**Helix Transport Consultants**

**Site: Land to the rear of No.5 The Green, Uley, Gloucestershire**

**Development: Improved vehicular access and parking area and associated landscaping**

# General Arrangement showing key dimensions and Features

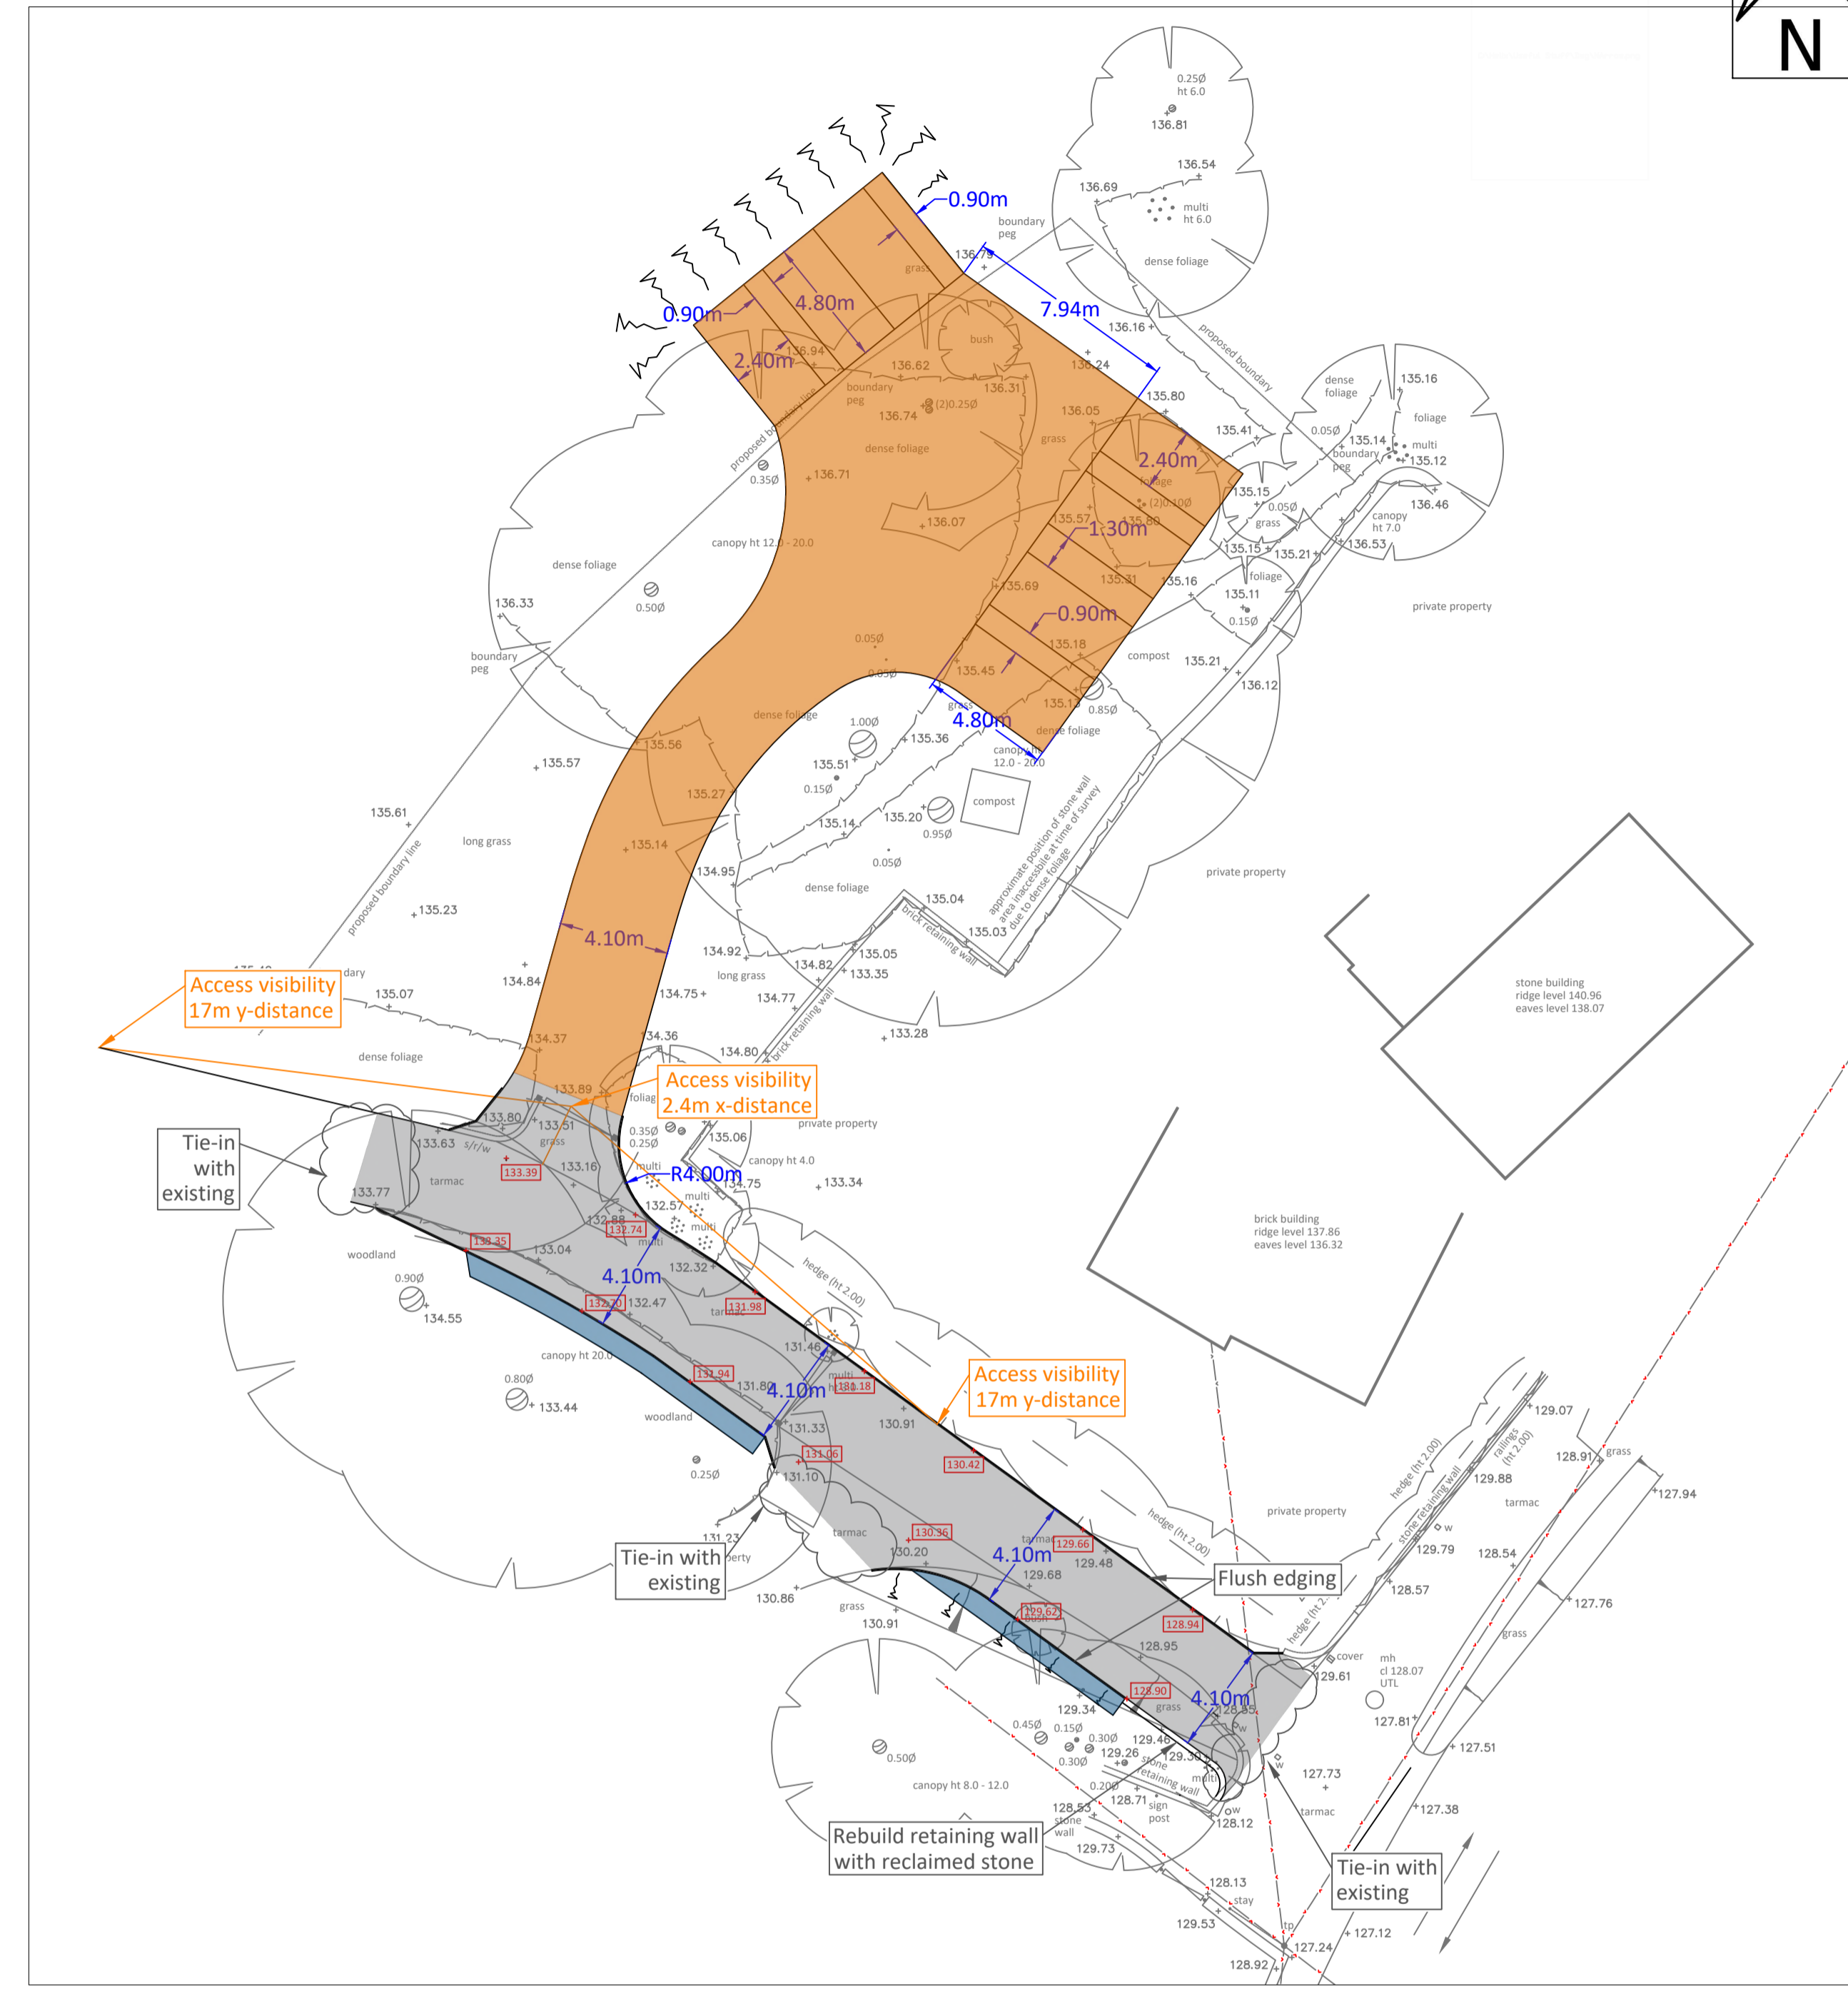
*The Manual for Gloucestershire Streets states new shared private accesses shall be a minimum of 4.1 metres wide within 15 metres of the behind the back of the carriageway to allow two vehicles to enter and leave simultaneously.*

*Given the intensification associated with the 3 detached dwellings associated vehicle parking being relocated via the existing track to The Rectory and occasional church parking, it is required that the access track demonstrates two-way visible passing space from The Street to the new entrance.....*

*.... two-way passing width is not only required immediately off The Street and at the new car park entrance from The Rectory track edge but also from the track up to The Rectory to where it widens into the parking and turning space.*

*Drainage to prevent run-off across the intensified access track onto the footway and into The Street would be sought if suitable passing space can be demonstrated.*

Accordingly, the current proposals, shown on the enclosed drawing 2330DWG01 rev A, differ from the previous proposals by allowing for a 4.1m wide surface all the way to the site entrance. This addresses all previous comments relating to the provision of passing spaces and the inter-visibility thereof.

In order to address the concern, the improvement proposals allow for an infiltration trench alongside the widened accessway. Proposed resurfacing works will re-grade the access so that the surface run-off is tipped into the infiltration trench.

# Vehicle Manoeuvres at the Junction with The Street

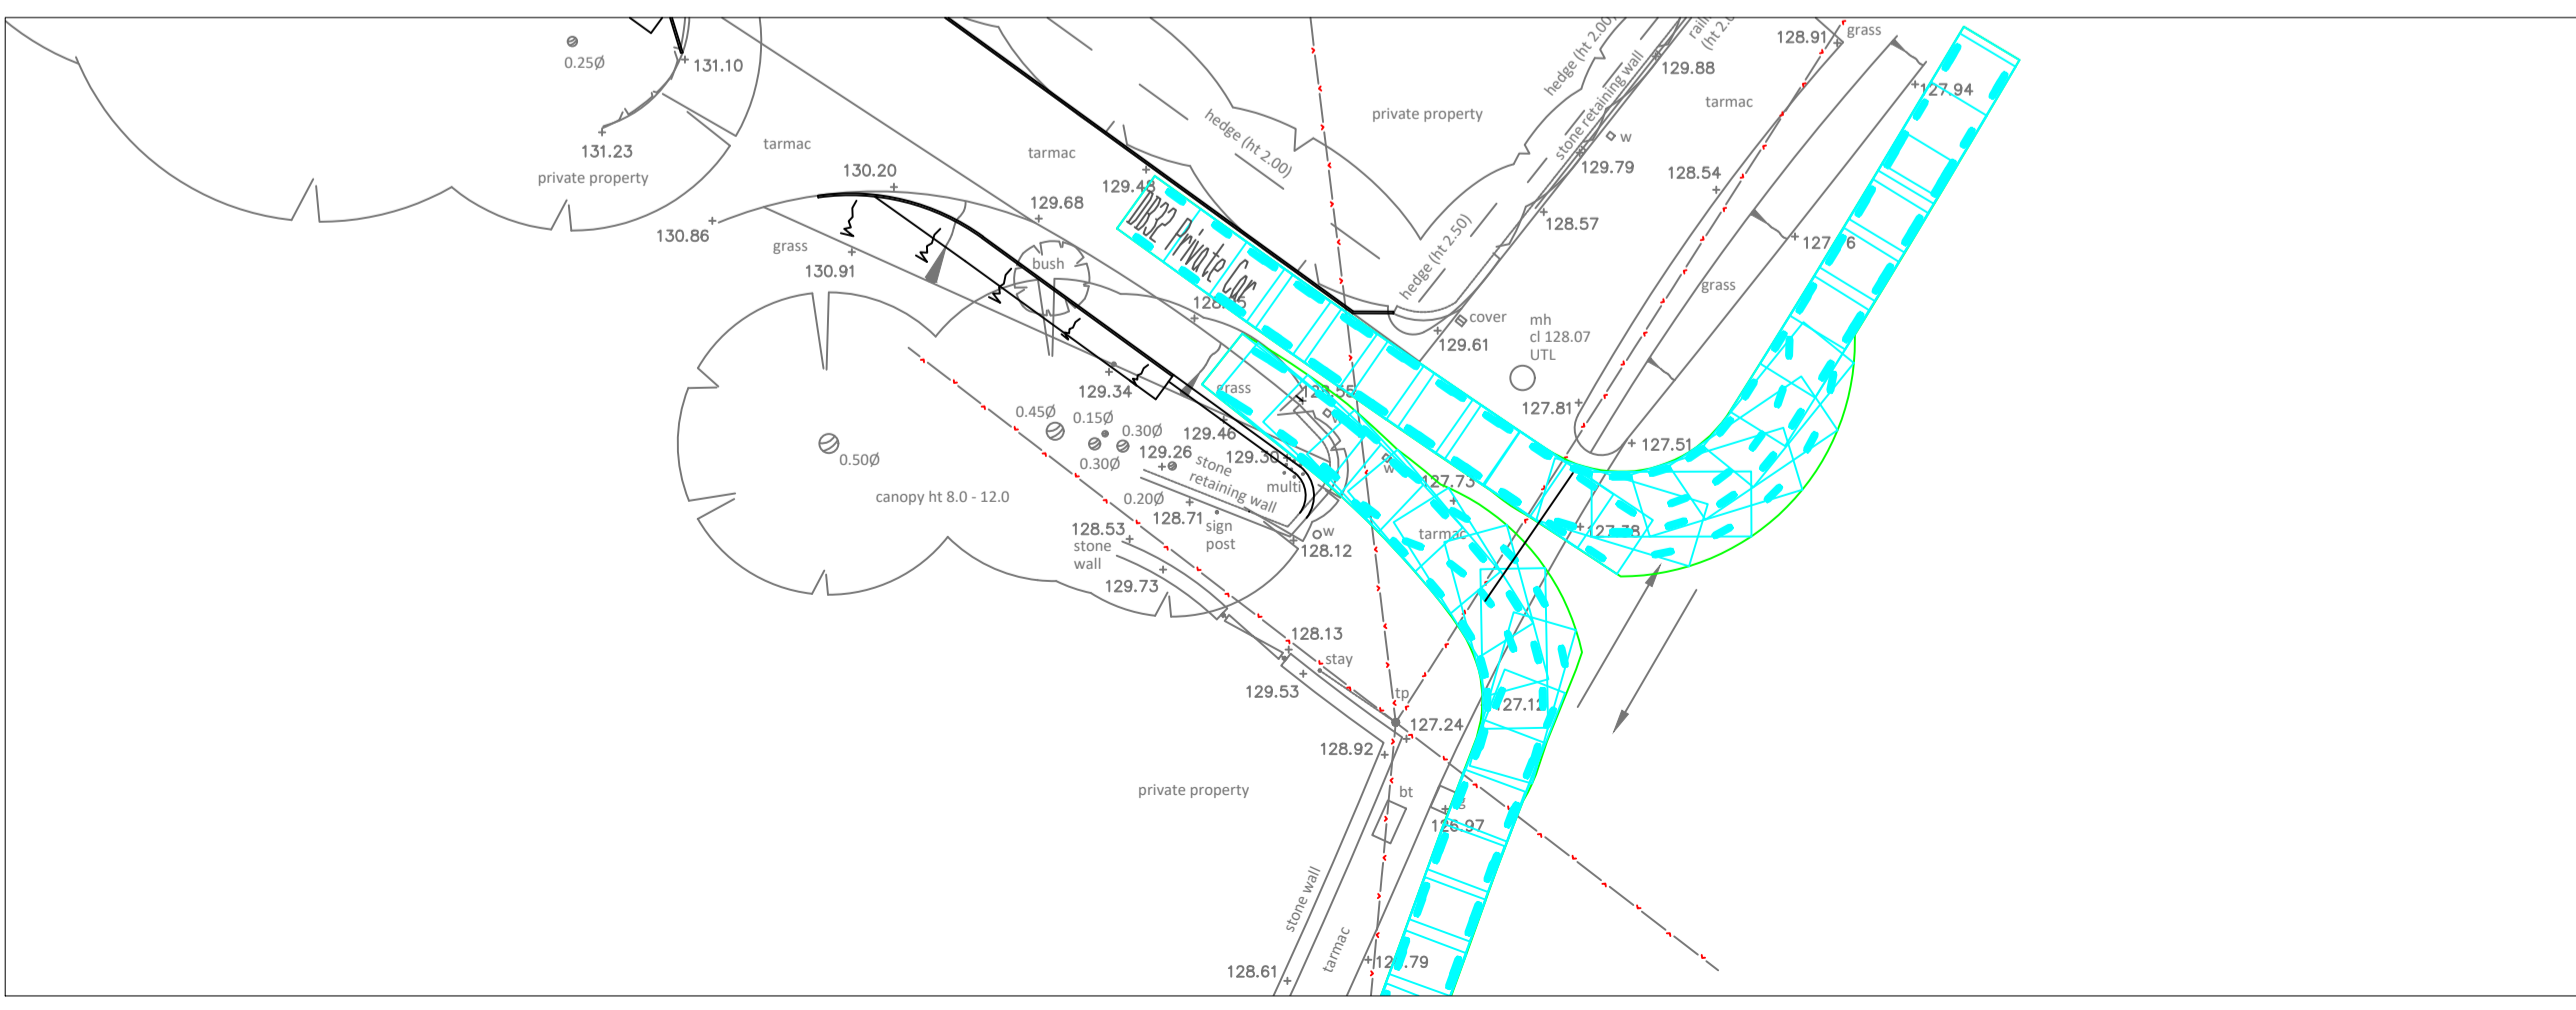
The highway authority has, in their response to S.23/1552/FUL, identified their minimum width requirement for the access to be 4.1m for the first 15m. This is to allow the two-way passage of cars at the entrance. Further comments indicate that, beyond the first 15m a single lane width would suffice so long as suitable passing opportunities are provided.

The highway authority recommends passing spaces at the entrance to the church parking and at the proposed site entrance. In effect, their comments recommend a two-way road between the Street and the site.

By allowing the two-way passage of vehicles, the current proposals eliminate the potential for hazardous vehicle reversing manoeuvres. This measure will benefit new and existing users alike and, as such, offers betterment in highway safety terms.
